**[Docket No. FAA-2007-28688; Directorate Identifier 2005-SW-21-AD; Amendment 39-15312; AD 2007-26-10]**

#### Airworthiness Directives; Bell Helicopter Textron Canada Model 430 Helicopters

**SUMMARY:** This amendment adopts a new airworthiness directive (AD) for Bell Helicopter Textron Canada (BHTC) Model 430 helicopters that requires replacing a certain servo actuator-to-actuator support attachment bolt (bolt) with an airworthy bolt. This action also requires establishing a retirement life for certain bolts and recording the retirement life on a component history card or equivalent record. This amendment is prompted by further evaluation of certain fatigue-critical parts, resulting in establishing a life limit of 5,000 hours for the affected bolts. The actions specified by this AD are intended to prevent fatigue failure of the bolt and subsequent loss of control of the helicopter.

Figure 1

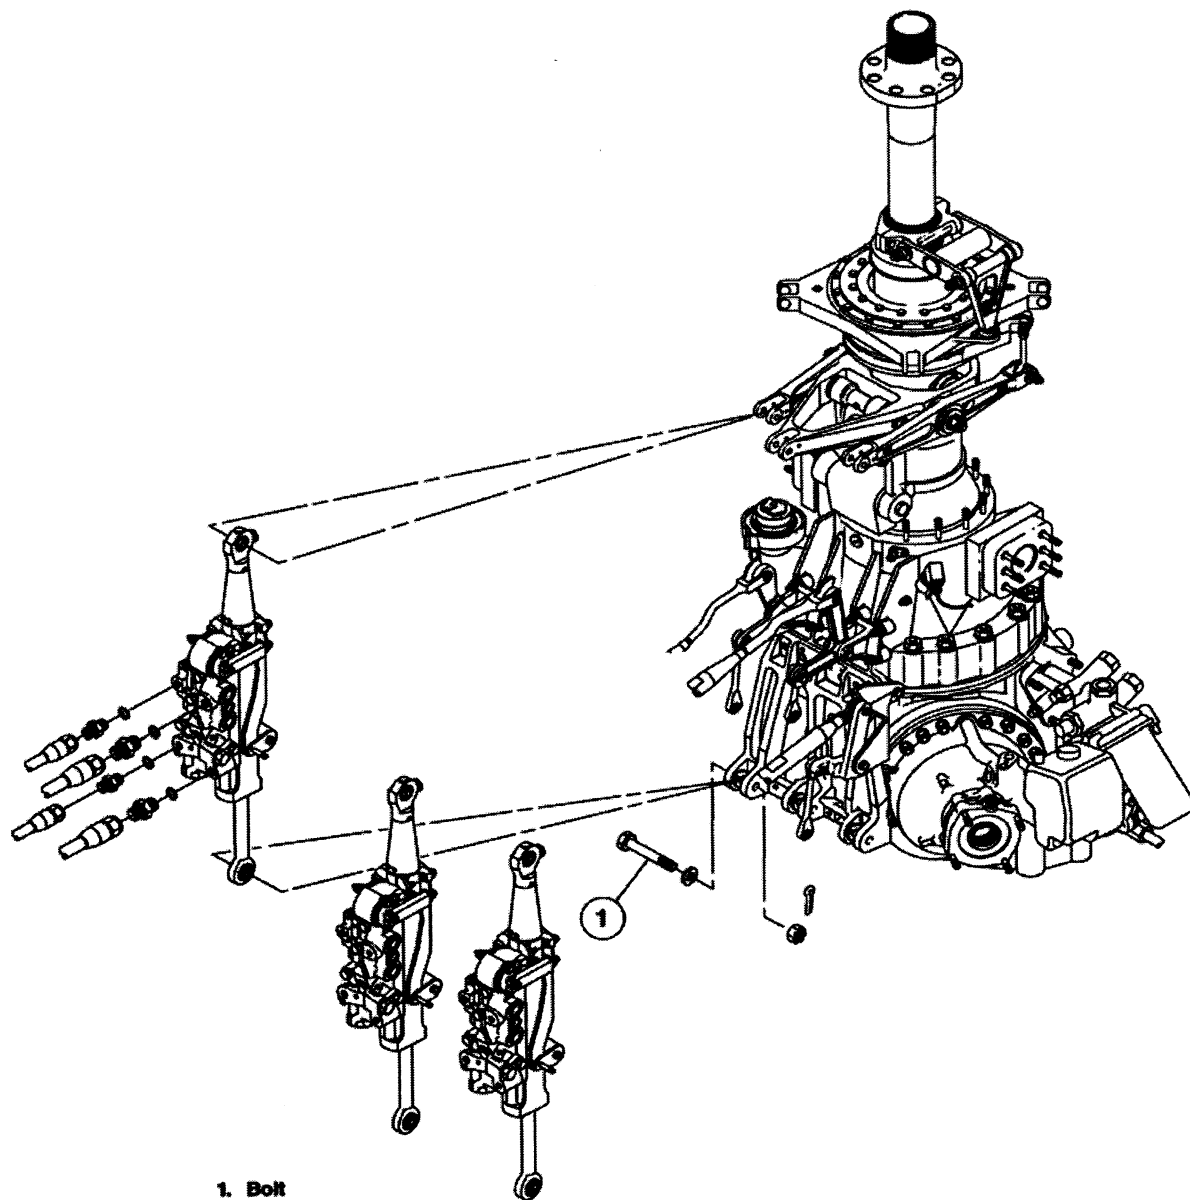
- (a) Within 150 hours time-in-service (TIS), replace all three affected bolts, as depicted for one of these bolts in Figure 1 of this AD, with airworthy, zero-time bolts, P/N 50-047C8-31.

**Note 1:** Only the right servo lower attach bolt (1) is shown. The collective and left cyclic servo lower attach bolts are also to be replaced. (This AD does not apply to the same part-numbered bolts at the upper end of each servo.)

(b) This AD revises the Airworthiness Limitations section of the maintenance manual by establishing a retirement life of 5000 hours TIS for each bolt.

(c) Record a 5000-hour TIS life limit for each bolt on the component history card or equivalent record.
